# PLANNING COMMISSION AGENDA-REVISED

**TO:** Planning Commission  
**FROM:** Jerry Haddix, Village Administrator  
**RE:** Case 20-17P, Site Plan Review for Chipotle  
**DATE:** September 8, 2020

**VILLAGE OF SOUTH LEBANON**  
**Site Plan Approval Checklist**

CHITOTLE - SOUTH LEBANON  
SITE DIMENSION PLAN  
674 CORWIN NIXON BLVD.,  
VILLAGE OF SOUTH LEBANON, WARREN COUNTY, OHIO

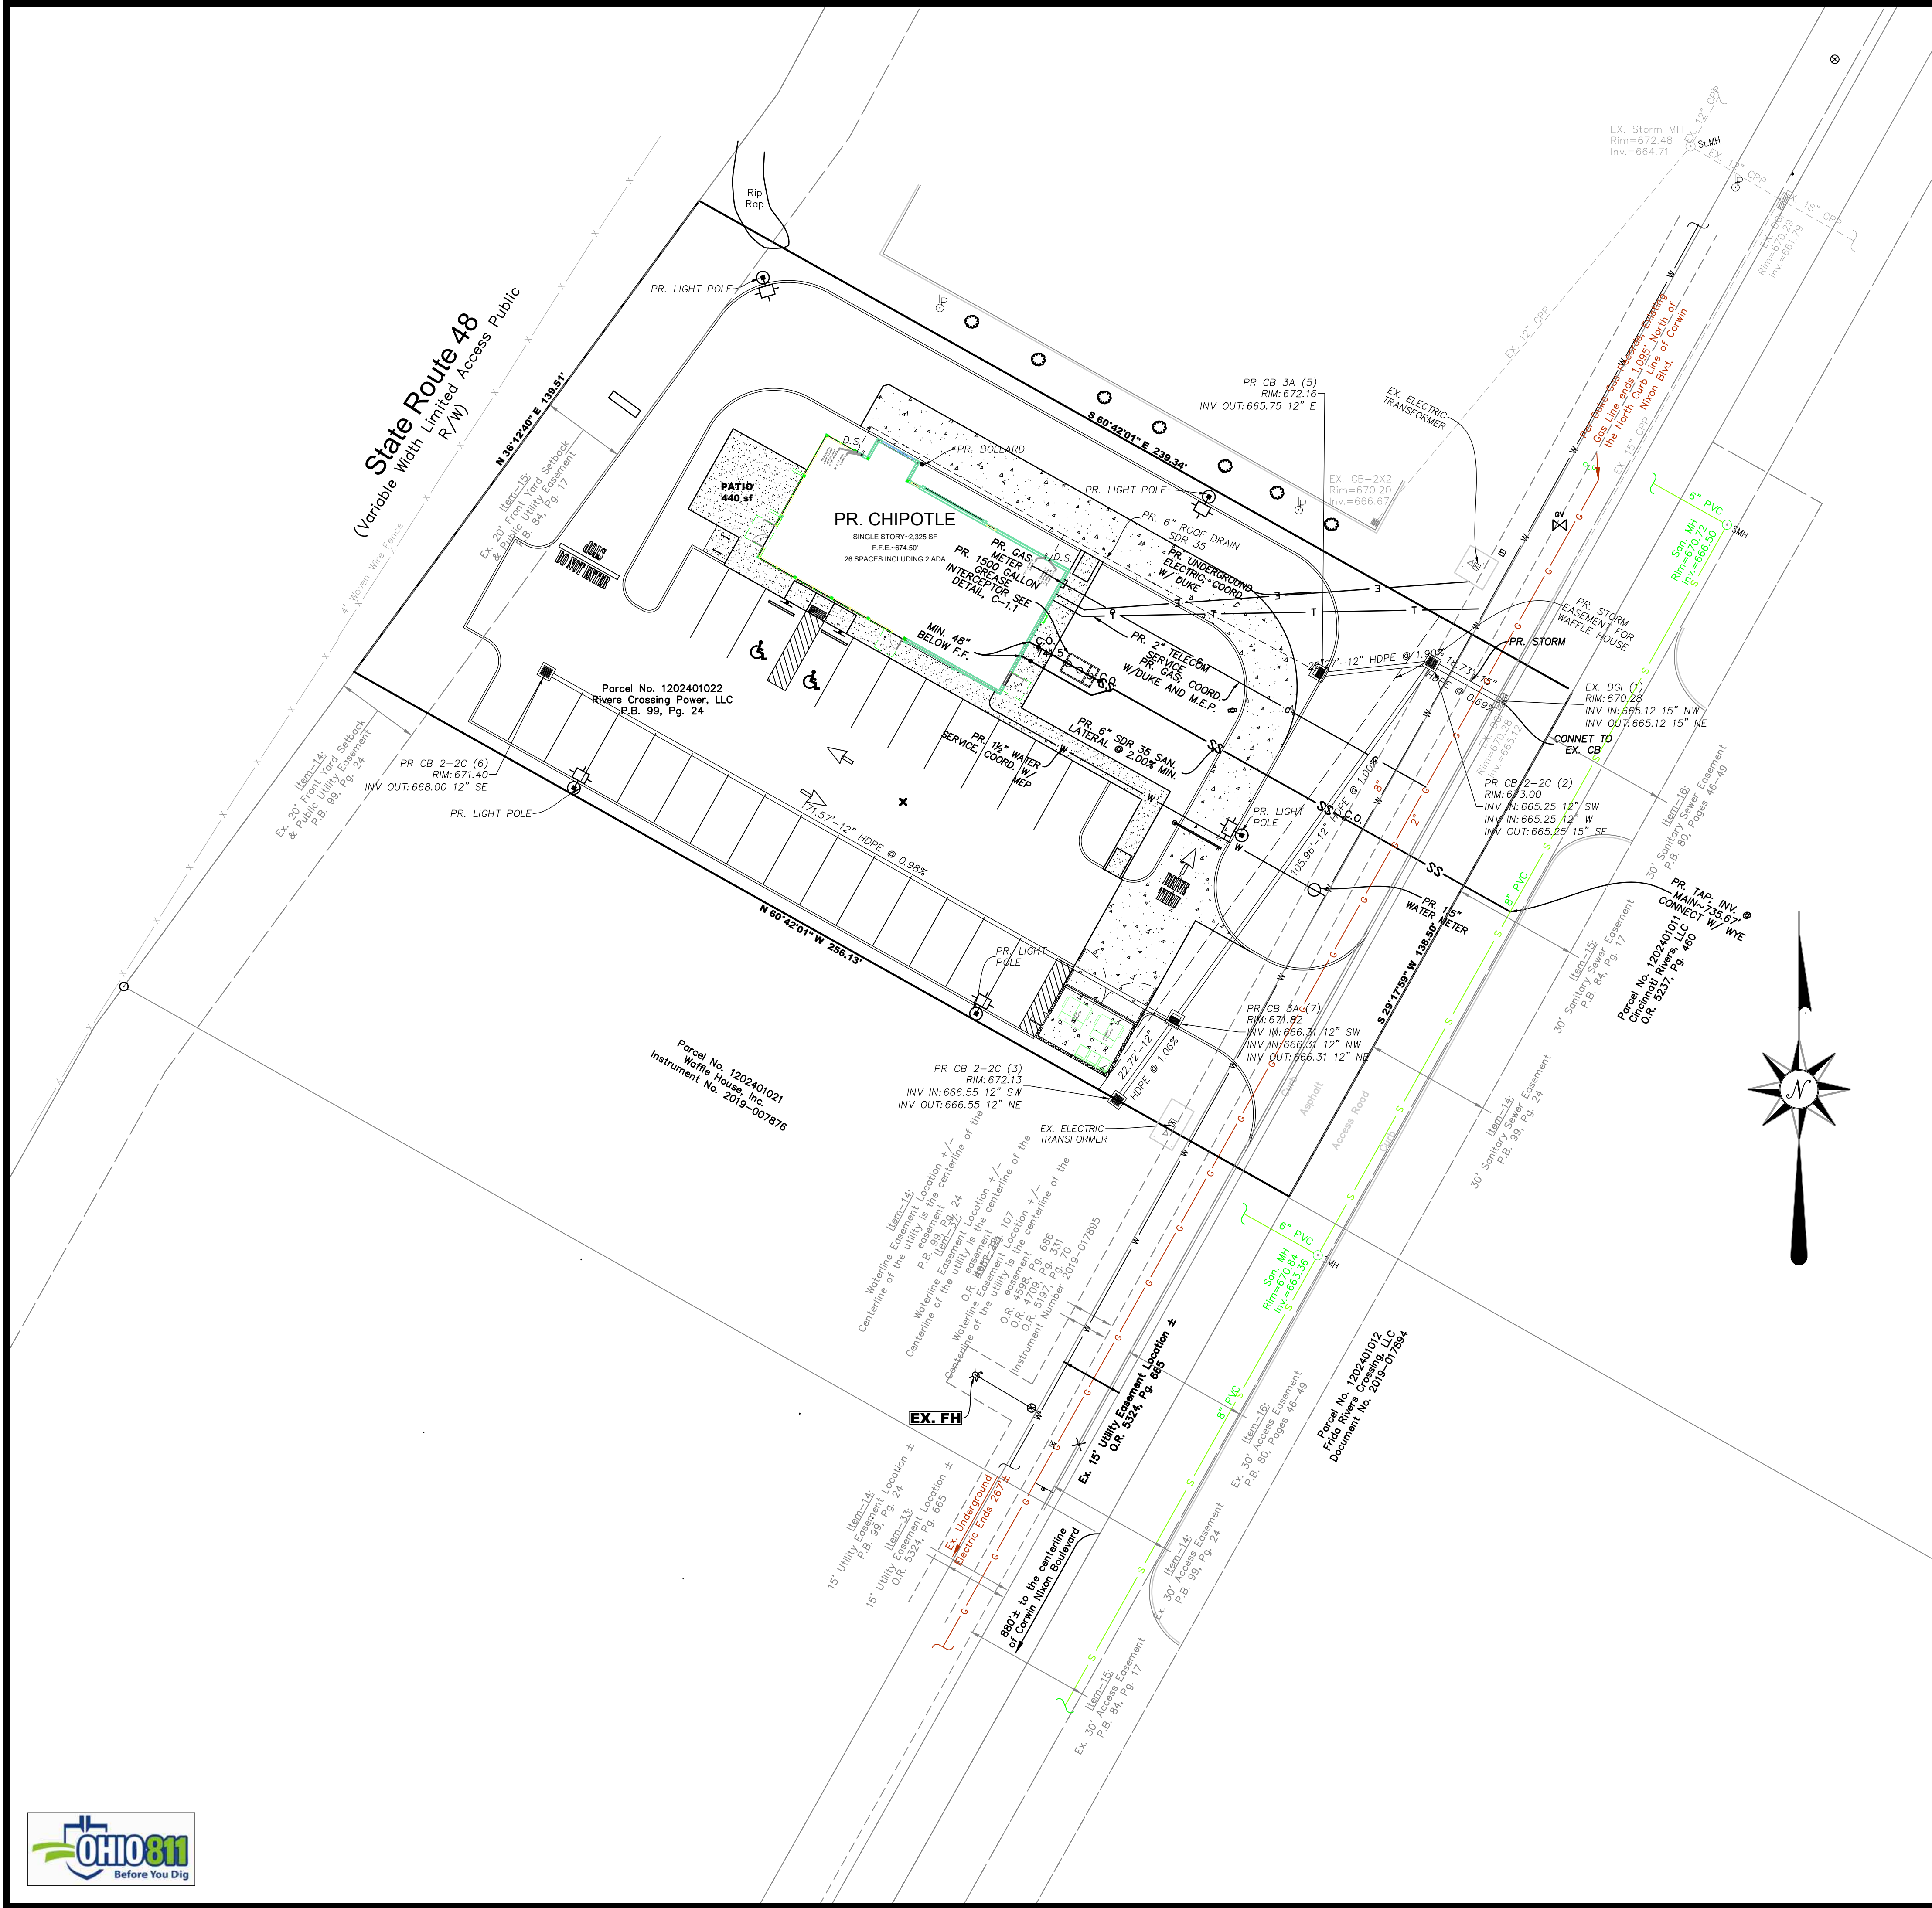
a. Sec 15.12.2 (1-12)	<input type="checkbox"/>	Revise ADA accessible stall that is only 8' wide. Min width for spot is 9'
b. Sec 15.12.3 and 15.12.7	<input checked="" type="checkbox"/>

LANDSCAPE PLAN

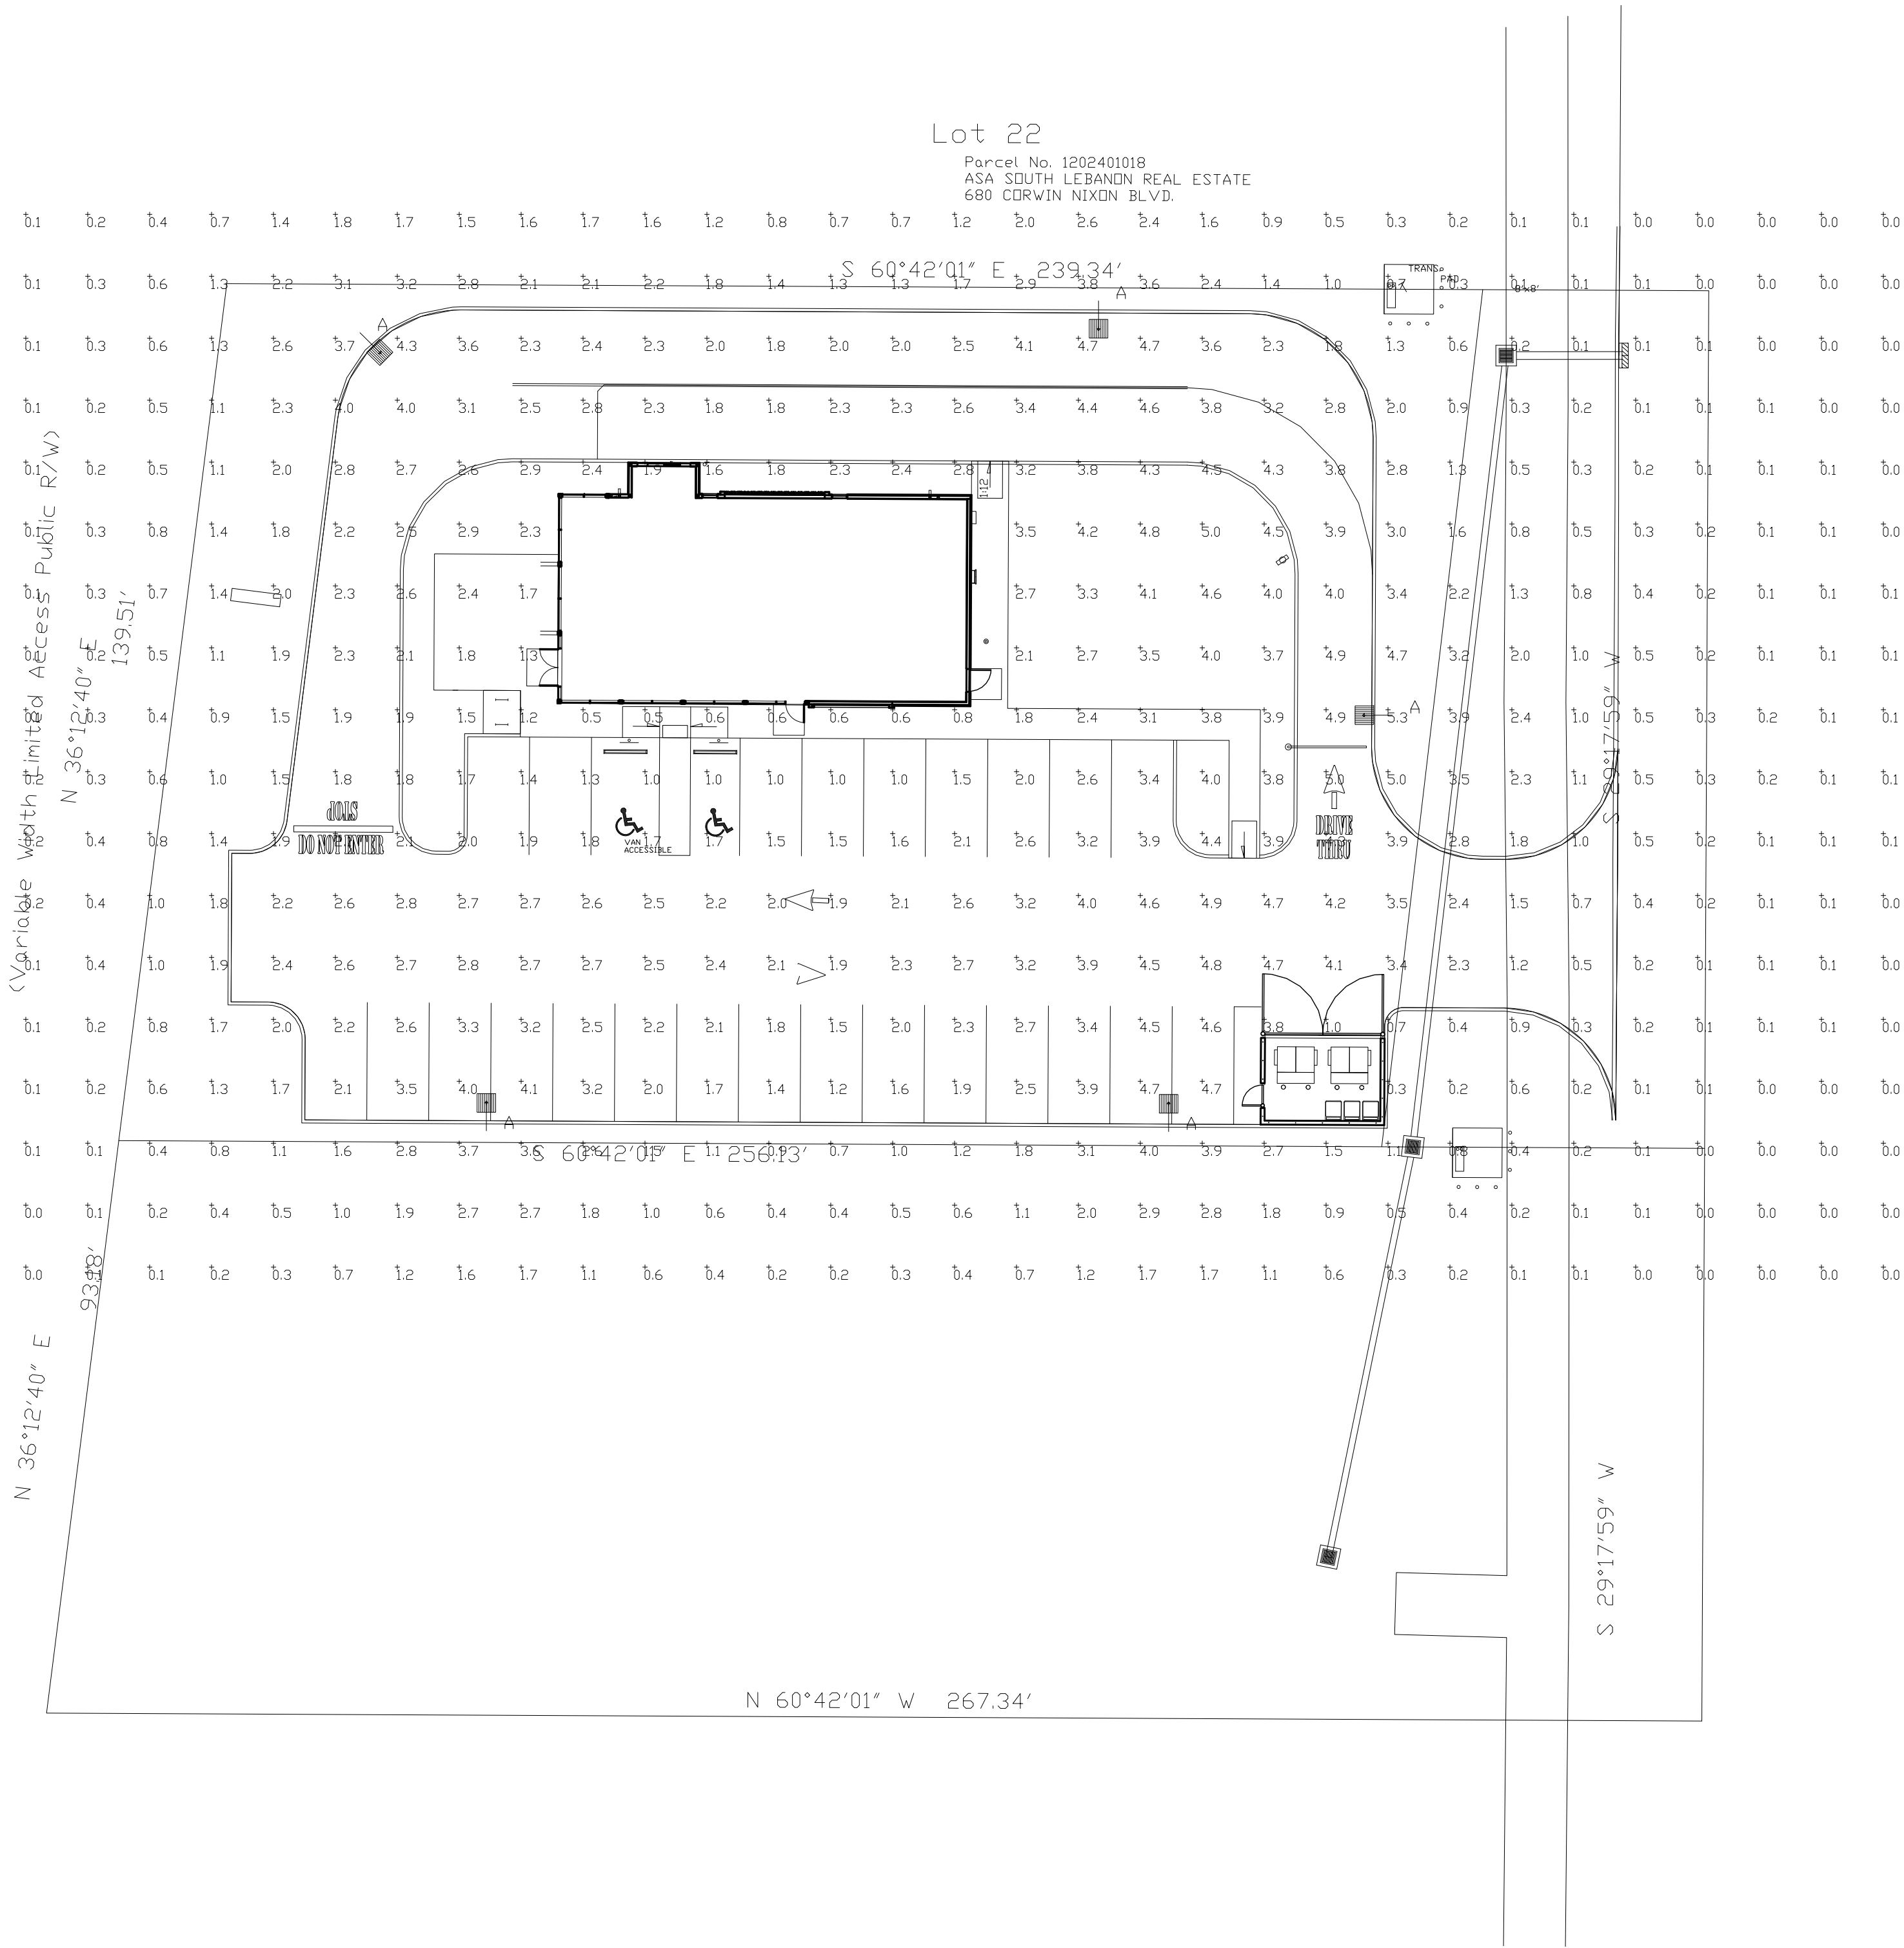
- All unpaved areas must be planted with grass, ground cover, trees or shrubs. 5% of the lot must be landscaped. ***There is interior landscaping and they have provided 1 shade tree and 43 shrubs next to the building on the State Route 48 side, 1 tree and 5 shrubs in the island next to the drive-thru and 3 trees and 8 shrubs along the frontage of Corwin Nixon.***

- 15.17.5; All parking lots must be screened and the screen must be 10'-0" wide with a 30" continuous screen planting or decorative wall. There must be 1 deciduous tree per 30 lineal feet. There is 233 linear feet along the parking lot side of the lot (south). ***8 trees are needed with a continuous screen. There is only 5'-0" between the parking area and the lot next door. No landscaping is shown.***
